Conservation Commission Meeting

Subject: Request to Extend Existing Order of Conditions
Order of Conditions (DEP File No, 321-0169)
551 Rear Arsenal Street, Arsenal Park Phase A Improvements

Re: 57 Coolidge Ave – DEP 321-0175 WWO-2021-02 (the "Project")
Bio-retention detail revision

Regarding: 10-30 Manley Way
DEP file No. 321-0188
Response to Conservation Commission Comments

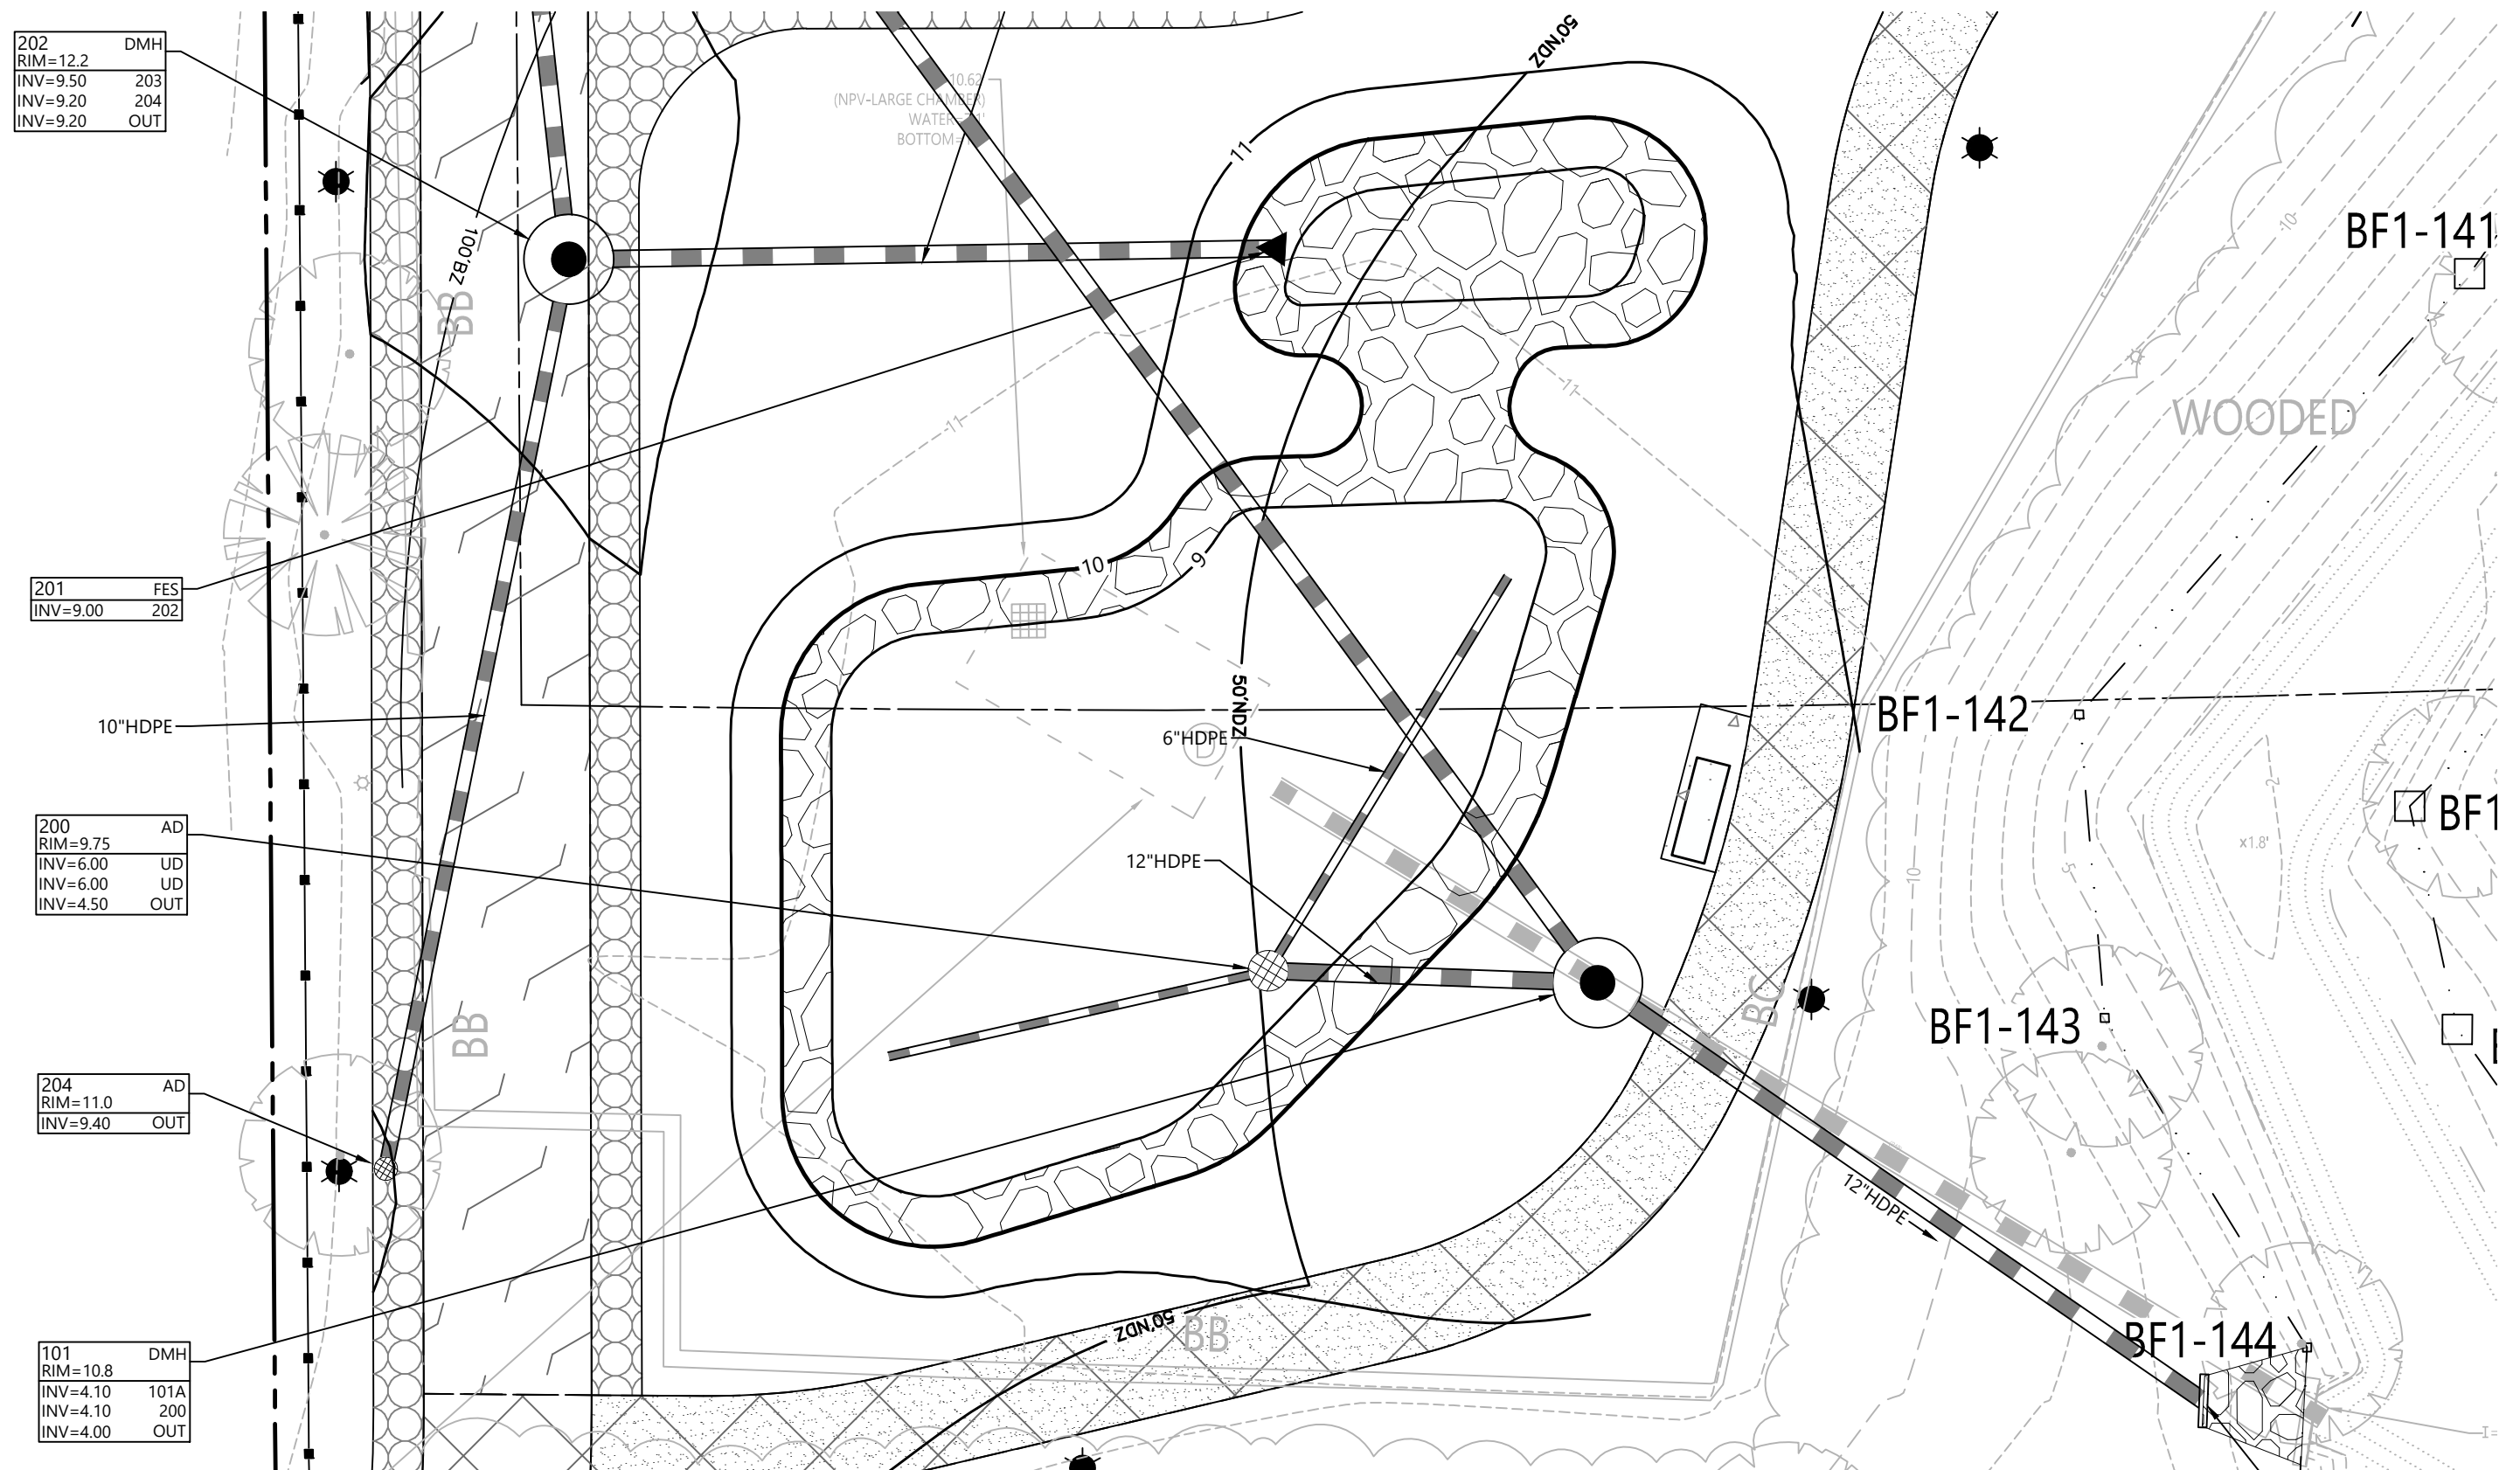
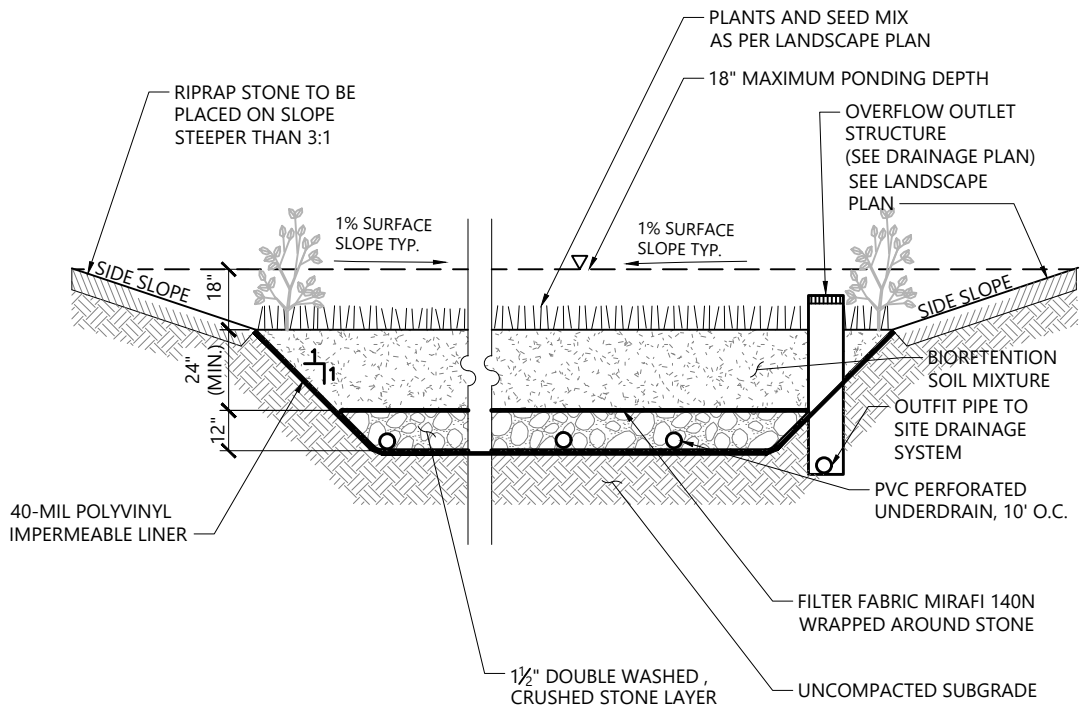
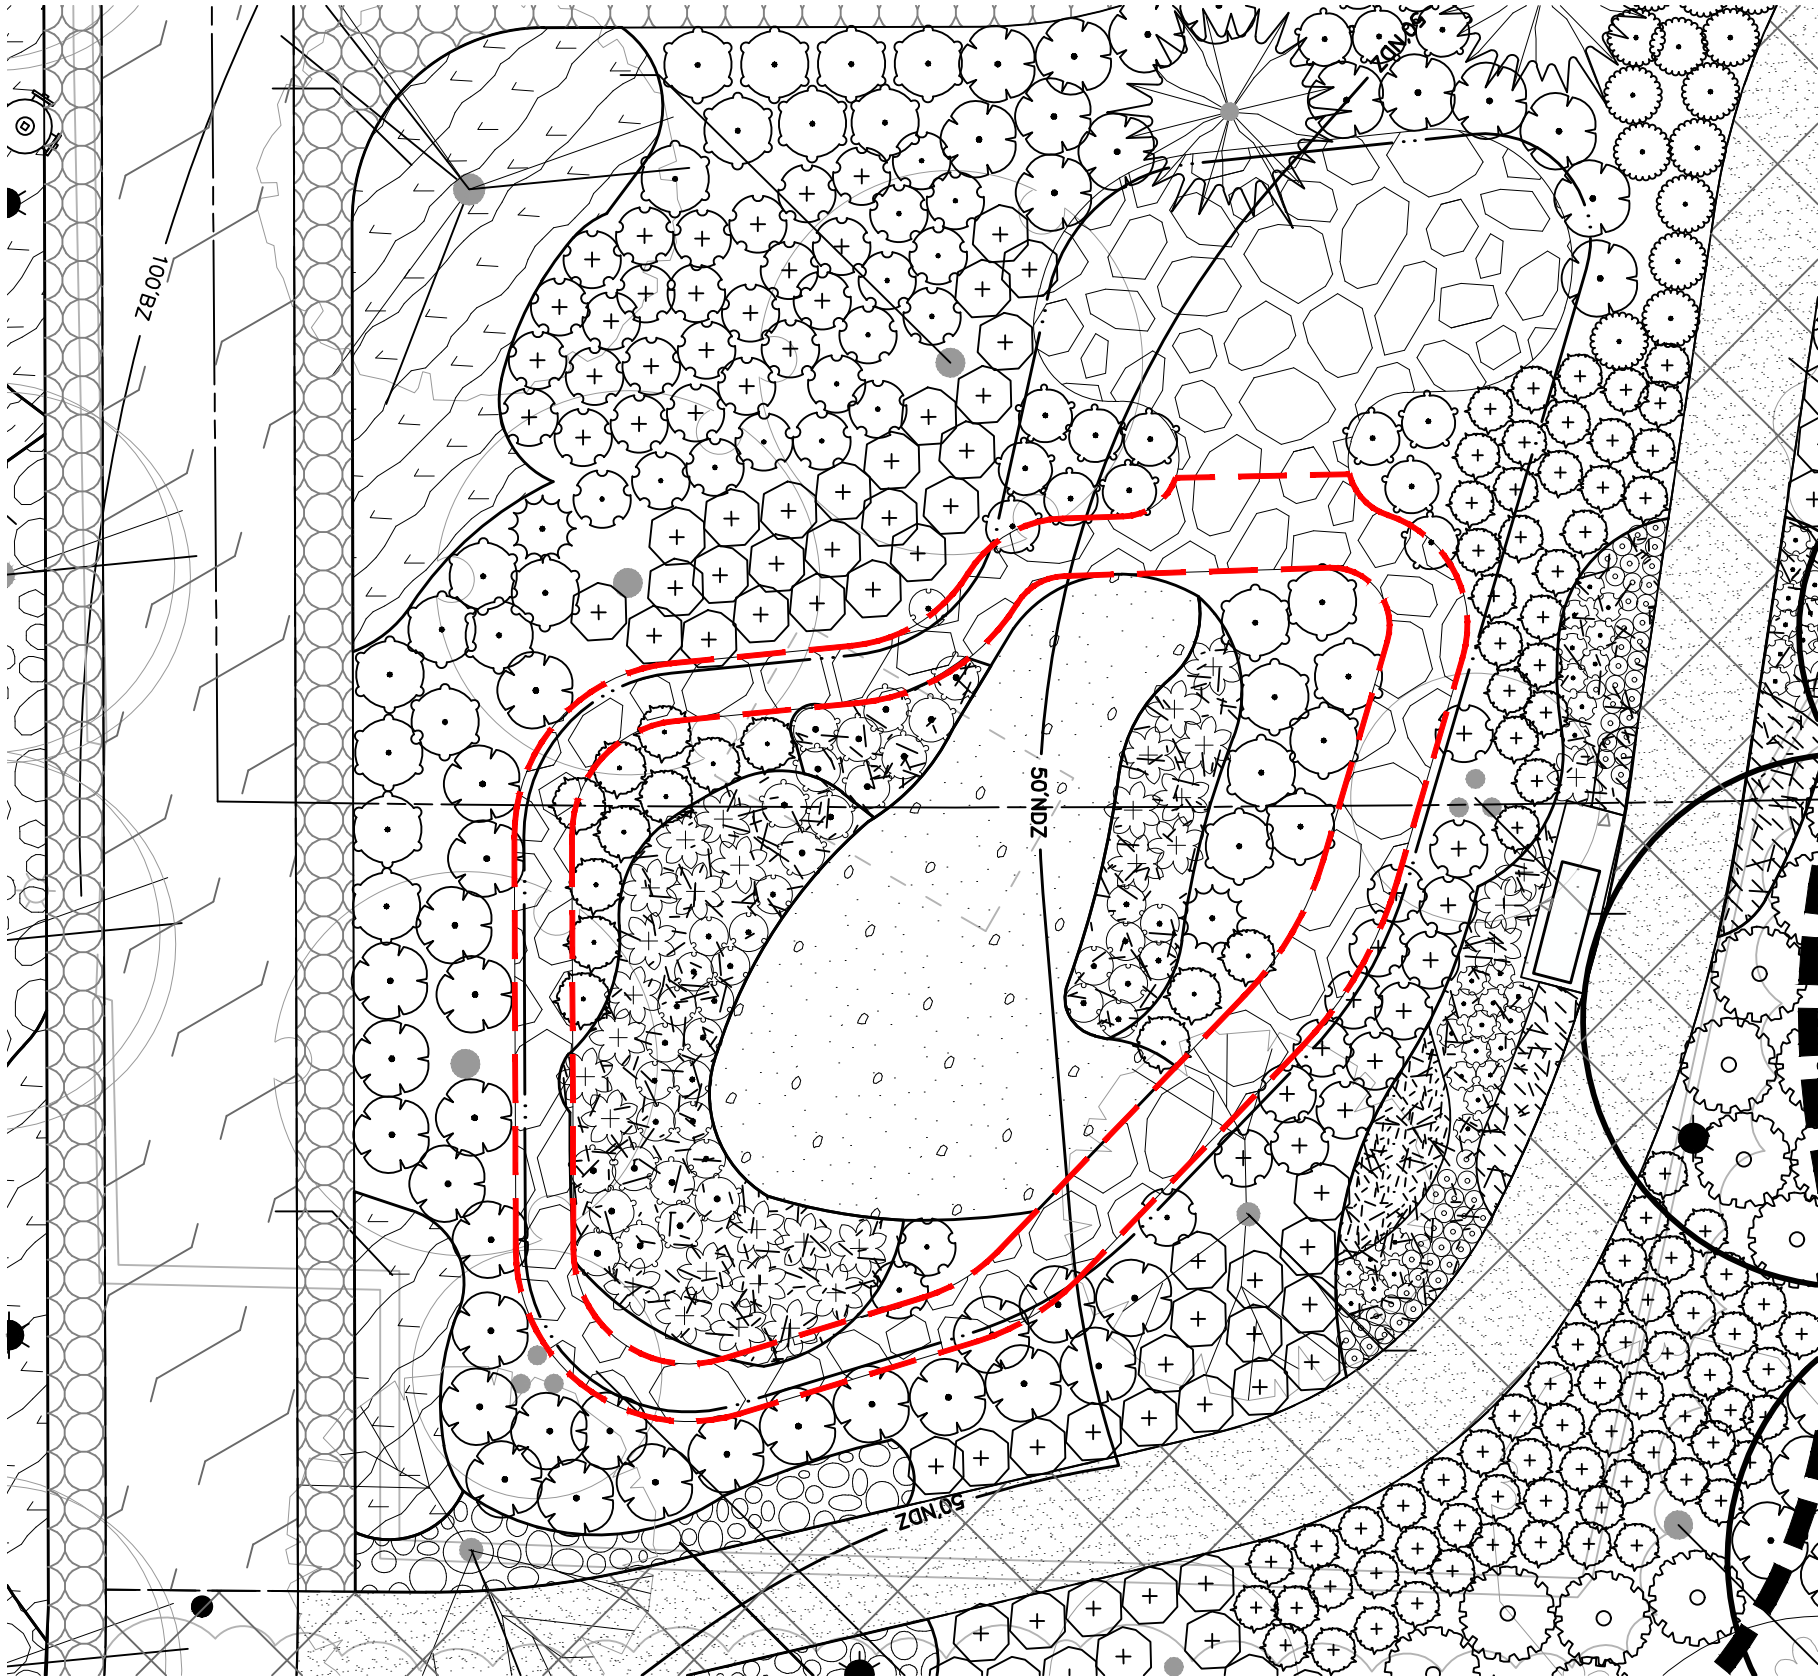
The placed stone does not limit the stormwater treatment function of the basin. The treatment is provided by virtue of the settling stormwater percolating into the bio-retention soil mix below the basin.

As such it my recommendation that the stone be left in place so as not to disturb the stabilized soils both in and around the basin.
